Entergy Operations, Inc.  
1448 S.R. 333  
Russellville, AR 72801  
Tel 501 858-5000

Subject: Arkansas Nuclear One - Unit 1  
Docket No. 50-313  
License No. DPR-51  
Comments on Proposed NRC Bulletin 96-01,  
Supplement 1; Control Rod Insertion Problems

Subject: B&W Owners Group (B&WOG) Comments on Proposed NRC Bulletin Supplement Concerning Control Rod Insertion Issues Specific to B&WOG and FCF Fuel

Rodded Fuel Assembly Burnups versus  
Control Rod Drop Times

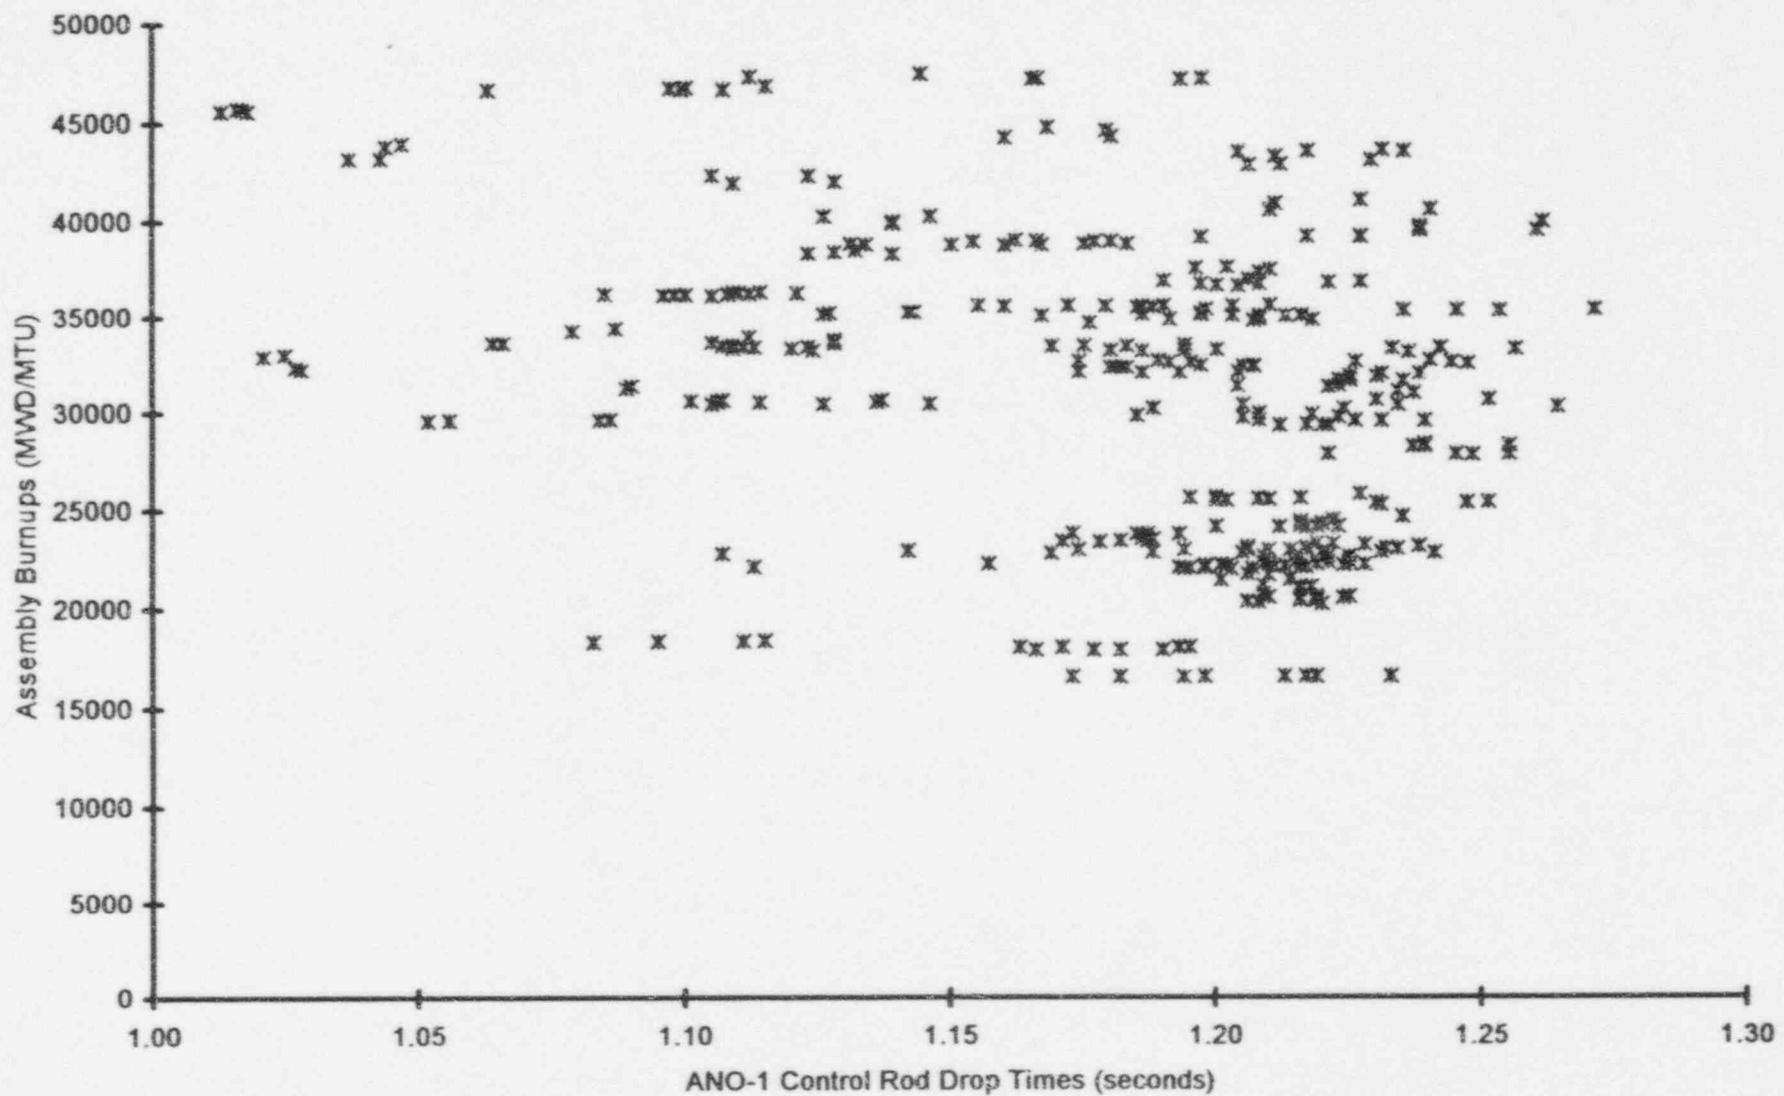
ANO-1 control rod drop time data over the past three years indicates no correlation between higher fuel assembly burnups and control rod drop times (see attached graph). This includes technical specification required control rod drop time testing at the beginning of cycle and unplanned reactor trip data. Also, on September 12, 1996, ANO-1 experienced a reactor trip at the end of a fuel cycle. At the time of the trip, 44 of the 60 control rods were located in fuel assemblies with burnups greater than 35,000 MWd/mtU, including 13 control rods which resided in fuel assemblies whose burnups were in the range of 43,000 to 48,000 MWd/mtU. The remaining 16 control rods were located in fuel assemblies with burnups greater than 31,000 MWd/mtU. When the reactor tripped, all control rods fully inserted as designed with no significant variation in previous control rod trip times. Therefore, ANO-1 fuel is not believed to be susceptible to exhibiting control rod insertion problems within the current licensed fuel burnup limits.
